A G E N D A
FARRAGUT MUNICIPAL PLANNING COMMISSION

May 15, 2014
7:00 p.m. Farragut Town Hall

SUBJECT: Discussion and public hearing on a site plan for a generator and propane tank at the Food Donation Connection at 12740 Kingston Pike (Food Donation Connection, Applicant)

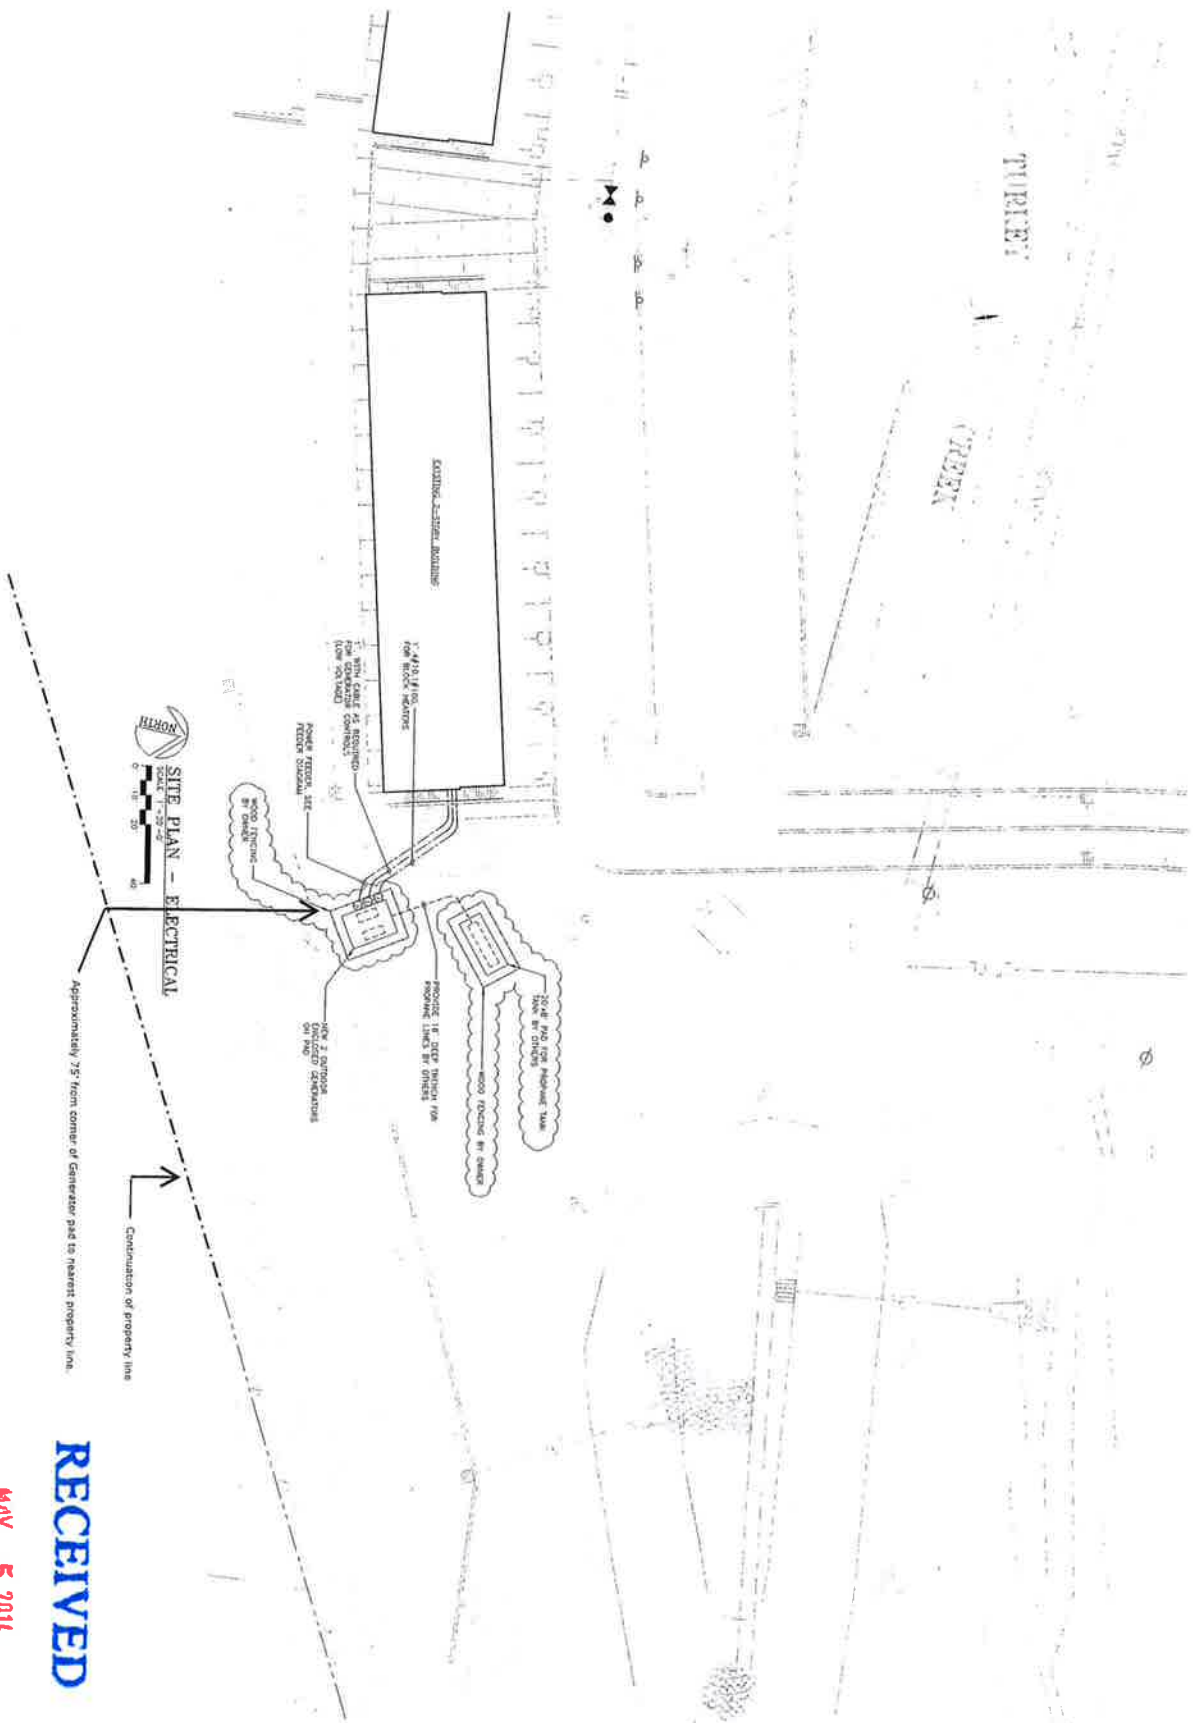
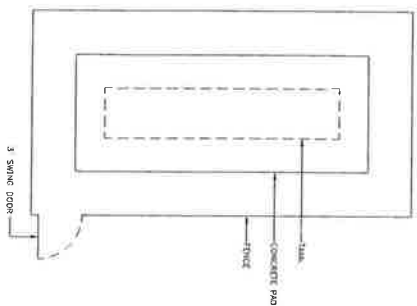
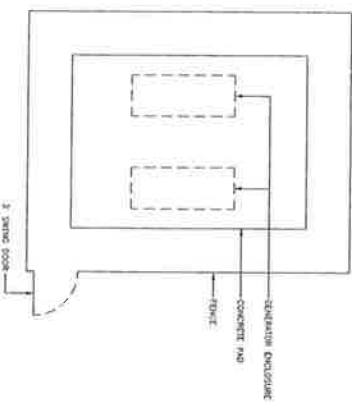
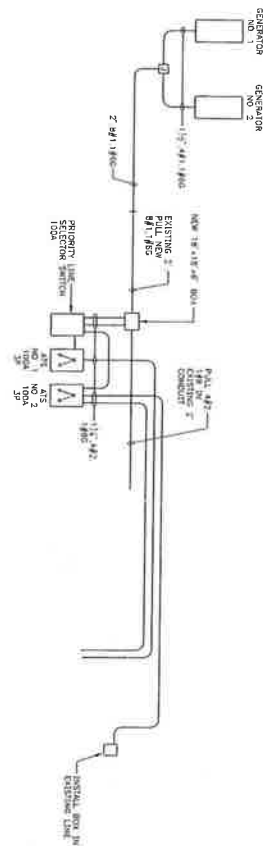
- 1) Please provide details on tank and pad;
- 2) Have you considered using natural gas in lieu of propane? This would eliminate the need for a tank and likely be less expensive and create less hazard potential;
- 3) Please provide fire hydrant data;

- 4) Please provide more information (e.g. size and volume) on propane tank. The staff would recommend using natural gas rather than propane (please see comment #2 above);

- 5) Please address how the proposed screening is architecturally compatible with the building the unit is serving. Is there fencing elsewhere. How will this be treated to be compatible with the building the unit is serving?
- 6) Related to the previous comment, please provide more information about the proposed screening. What type of gate is proposed?

- 7) Will any existing landscaping be damaged or removed as a result of this proposal? If so, please provide information on replacement material;
- 8) Please address in a note that the mechanical equipment will be screened per the zoning ordinance requirements so that they are not visible from adjacent properties or rights of ways;
- 9) Are you proposing any sidewalk to access the equipment proposed herein?
- 10) Please call out the distance between the proposed generator addition and the nearest property line; and
- 11) The generator appears to be very close to a 36 inch storm sewer. Though this sewer is not a Town maintained sewer, any work related to this sewer could conflict with the generator placement and may be a concern for the property owner.
